Clonburris SDZ,
Dublin 22

Ronan Mac Diarmada & Associates

ADDITIONAL INFORMATION RESPONSE

November 2022

Attenuation Tank Location Plan

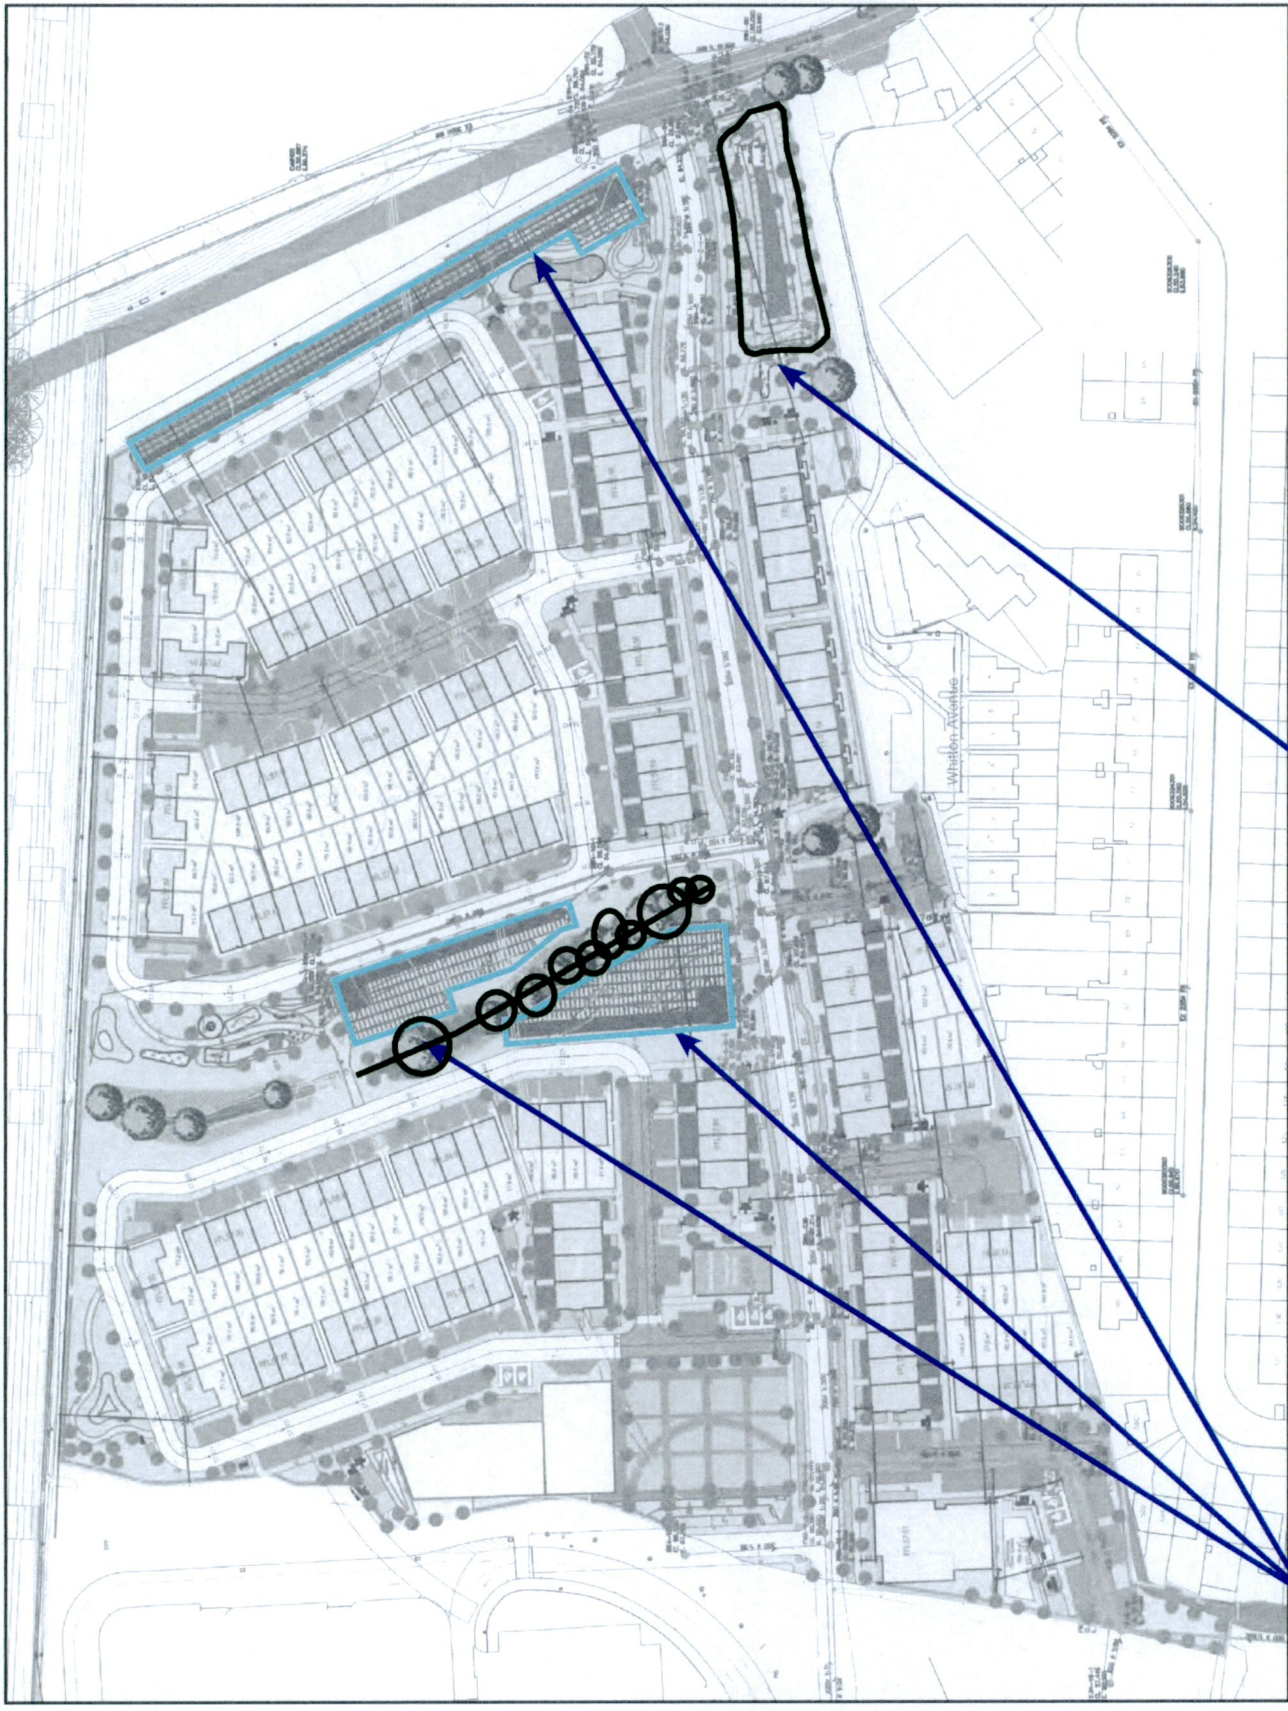
Surface Water Drainage. It is essential that open spaces accommodating SUDS measures such as attenuation ponds and swales are designed in order to achieve a balance between surface water management and high-quality open space. The applicant is requested to confirm that the attenuation tanks will not preclude the retention and protection of the existing north south hedgerow/tree line. If required these tanks should be moved to facilitate this. The permitted attenuation pond in the south-east corner of the site should be fully incorporated into the landscape and open space proposals. Further above ground SUDS measures should be incorporated into the overall proposal.

The proposed attenuation tanks in the open space were granted under a previous permission - SDZZ0A/002.

The permission states that they will not be removed. However, we invite the local authority to change the design due to proximity of tank to existing trees and hedge. This is the responsibility of the infrastructure works and the local authority.

The permitted attenuation pond in the south east corner of the site shall be incorporated into the landscape open space proposals.

We have provided for path and congregation space within this area. The planting shall be suited to wet/moist conditions.

All above ground SUDS measures shall be incorporated into the overall proposal into the overall proposal via the use of paths, seating, planting of trees & wildflower meadows.

Existing & New Native Hedgerow Plan

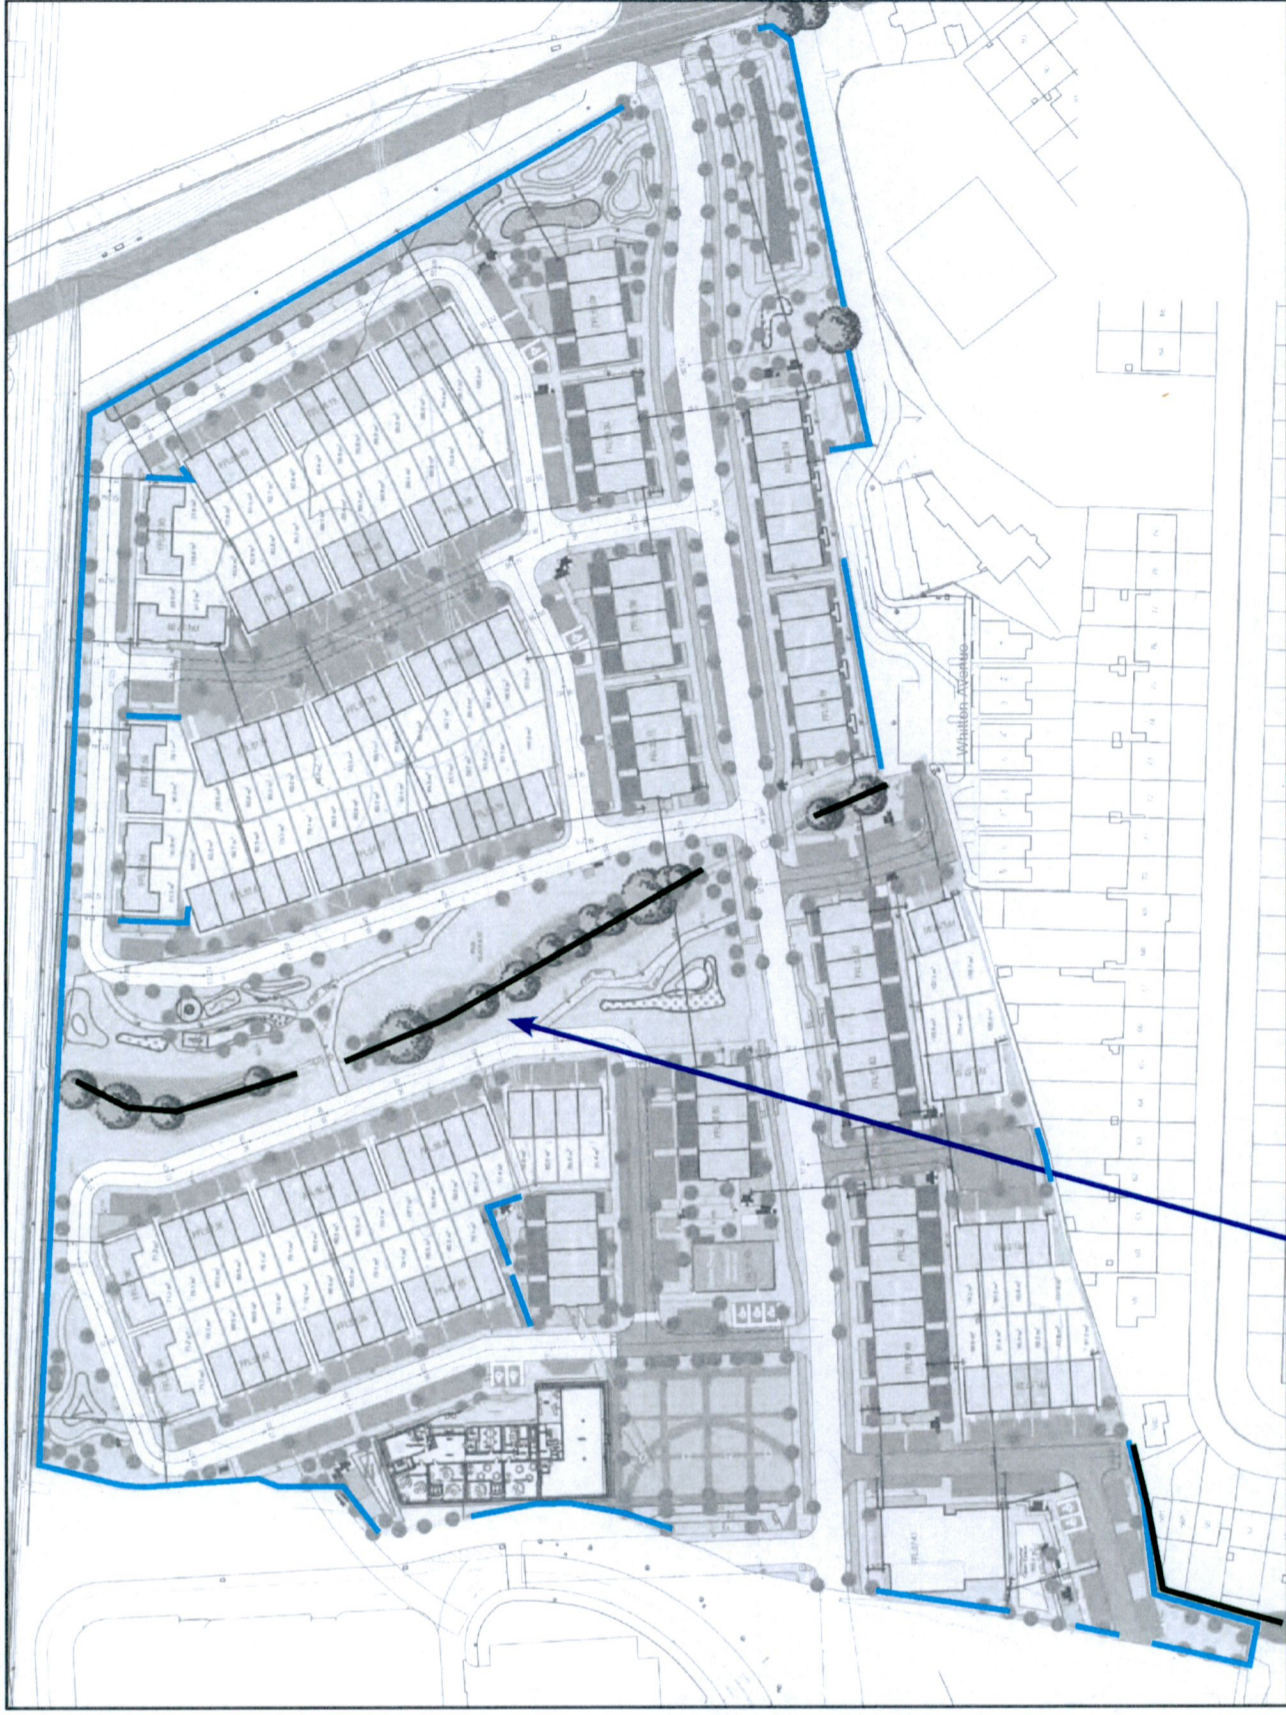
Landscape Plan. A revised detailed landscape plan, to be agreed with Public Realm, with full works specification, that accords with the specifications and requirements of Council's Public Realm Section. The revised landscape plan shall integrate retained and enhanced hedgerows and trees, tree planting and SuDS drainage to provide strong green infrastructure links throughout the development in accordance with Clonburris SDZ Planning Scheme, Parks and Landscape Strategy and Biodiversity Management Plan.

Please refer to Dwg 01 Landscape plan & full work specifications sheet for more detail in which we have sent to public realm for review.

The landscape plan indicates the retained hedgerow, tree planting & SuDS measures to provide the strong green infrastructure links throughout the development in accordance with Clonburris SDZ planning scheme & landscape strategy & biodiversity plan.

Tree Pit Location Plan

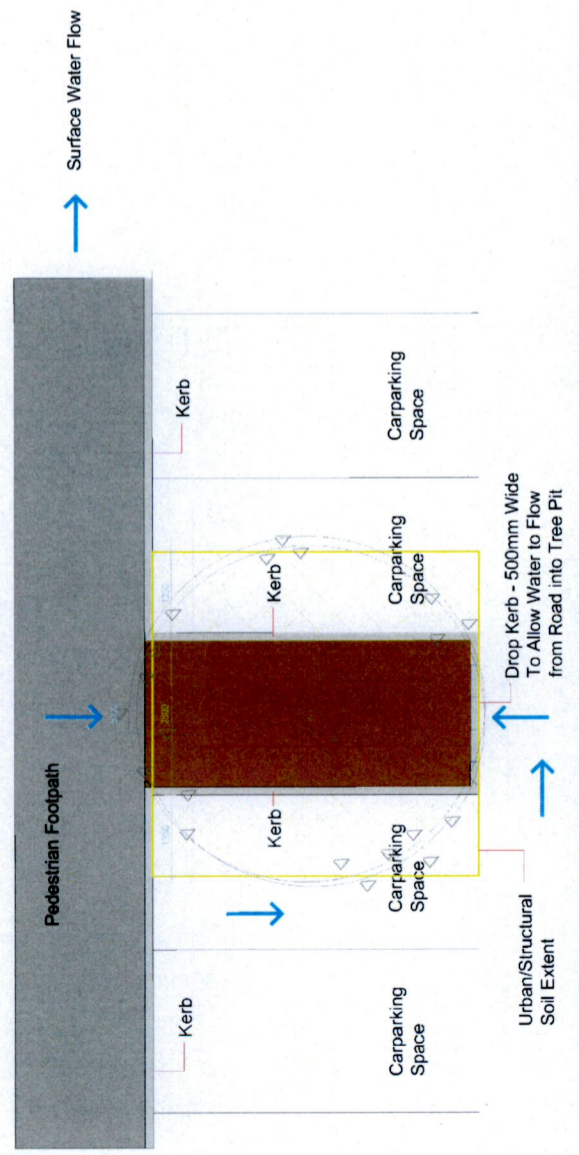
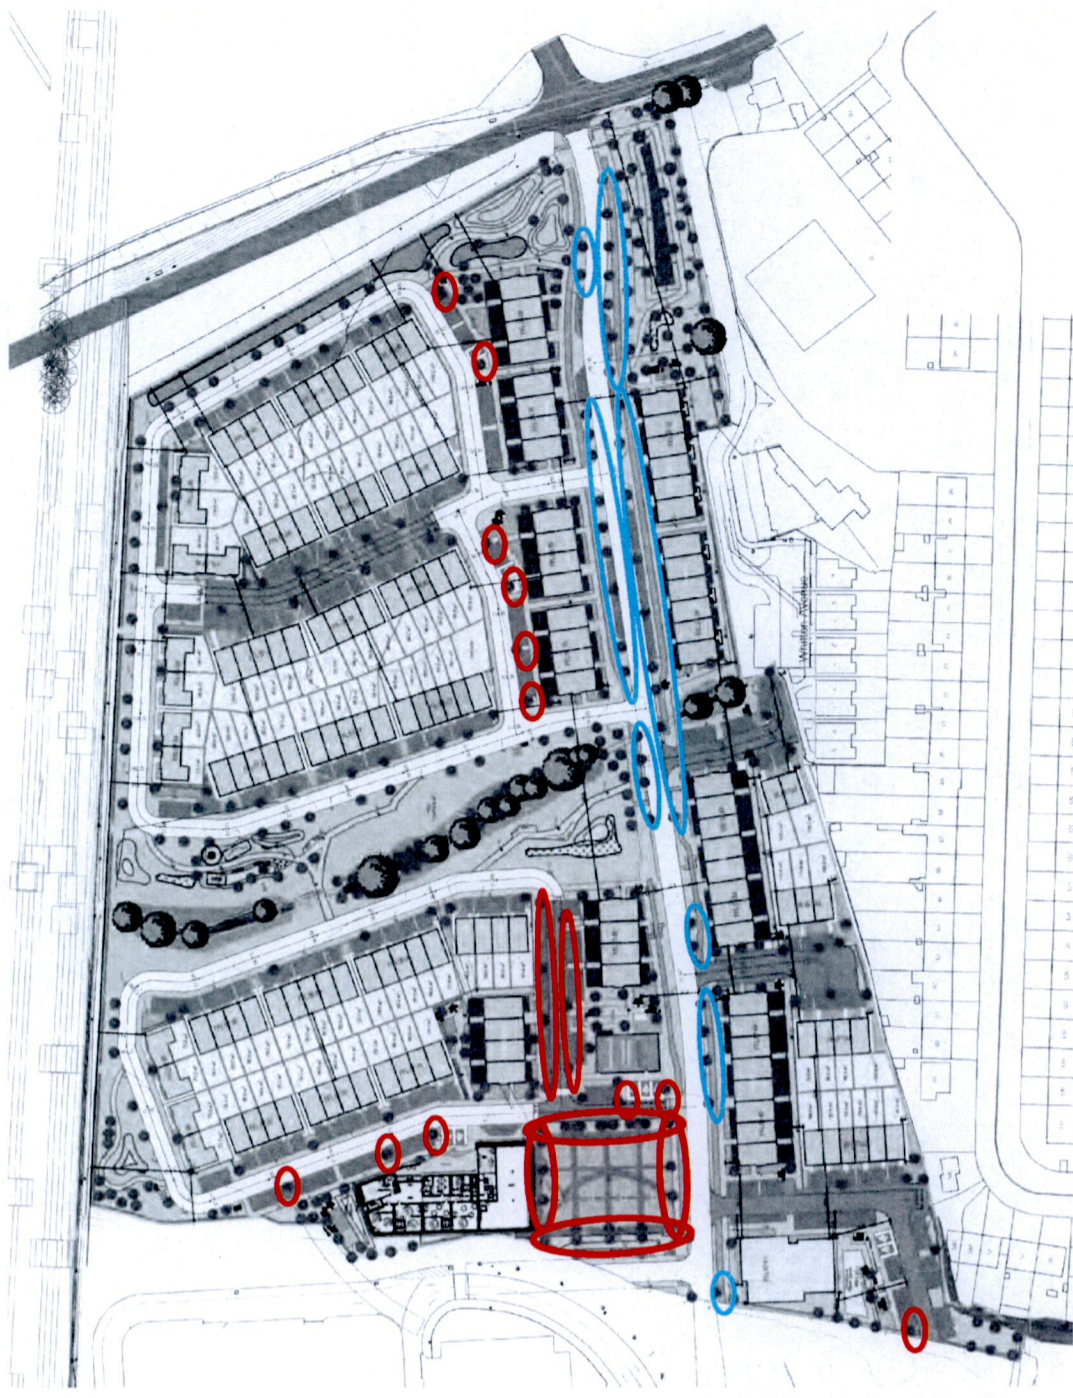
Street tree provision to incorporate small scale SuDS features that enhance biodiversity, provide amenity, manage surface water volume while providing water quality treatment.

Street tree provision shall incorporate small scale SuDS features that enhance biodiversity, amenity, manage surface water volume while providing water quality treatment.

Typical Tree Pit - Scale 1:25

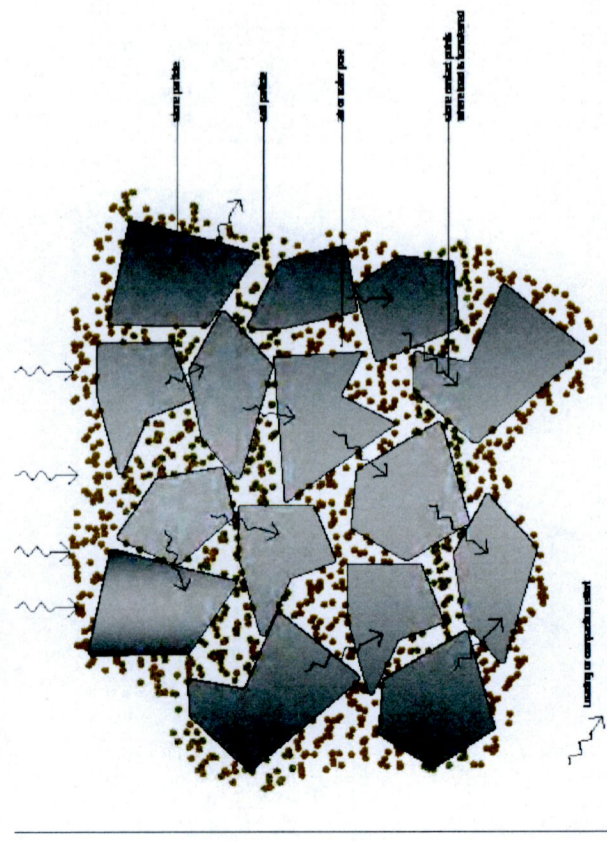
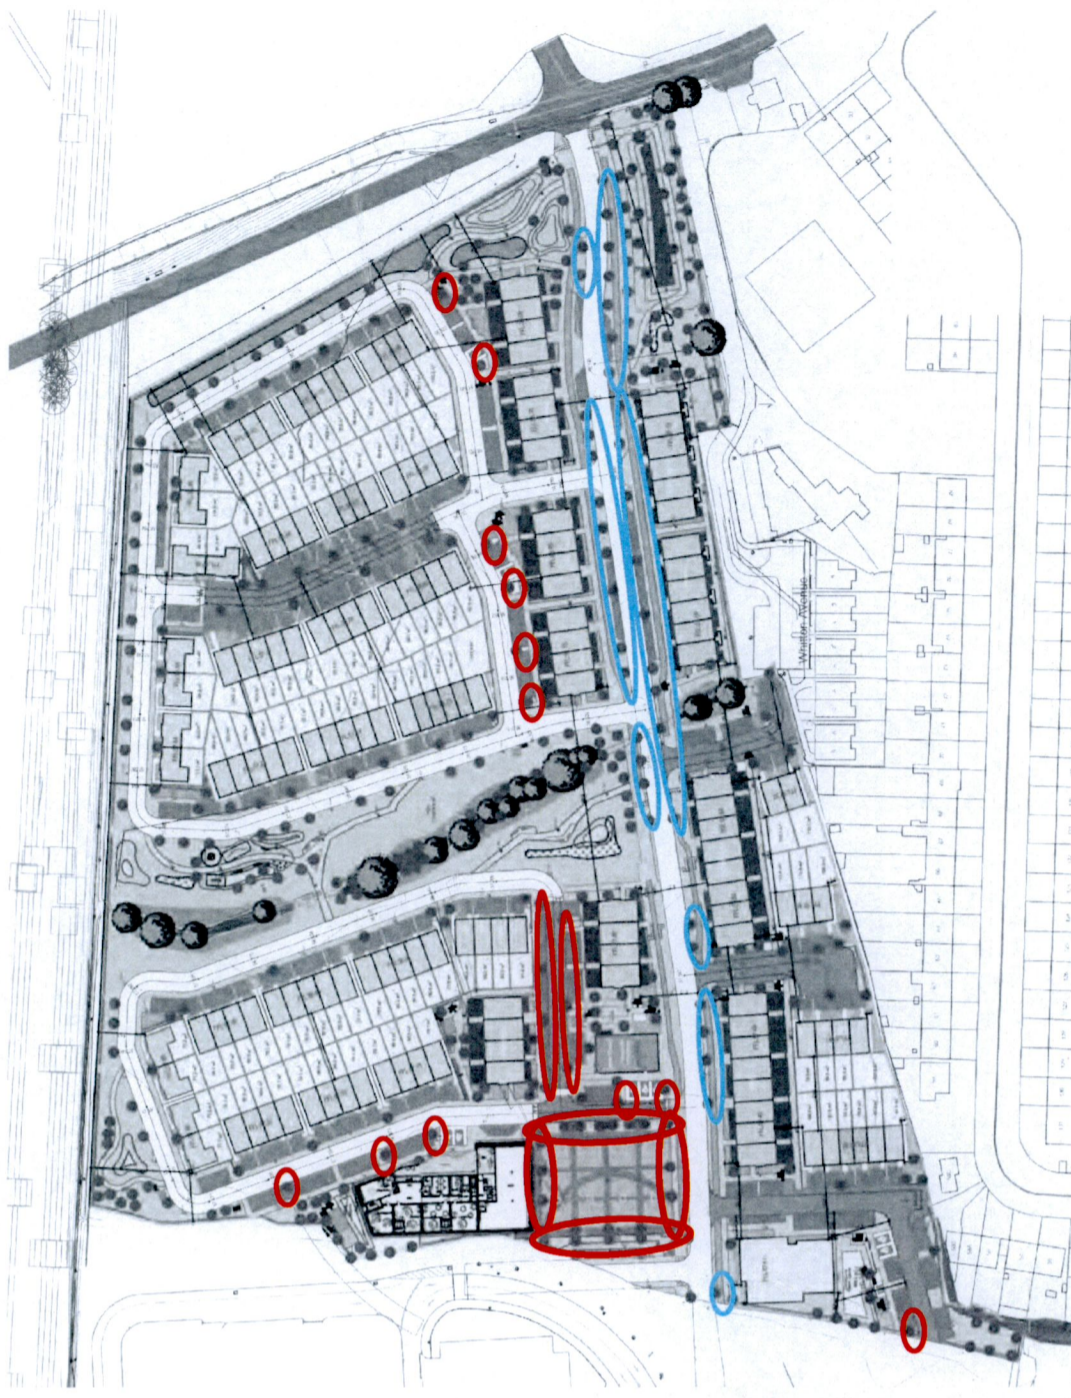
Details of street tree planting to be submitted to the Public Realm Section of SDCC for agreement. Urban tree pits to include SUDs measures / storm water attenuation. The developer shall submit cross section details of the SUDs tree pits, including growing and drainage/storage media

Please see detail of Urban Tree Pit.
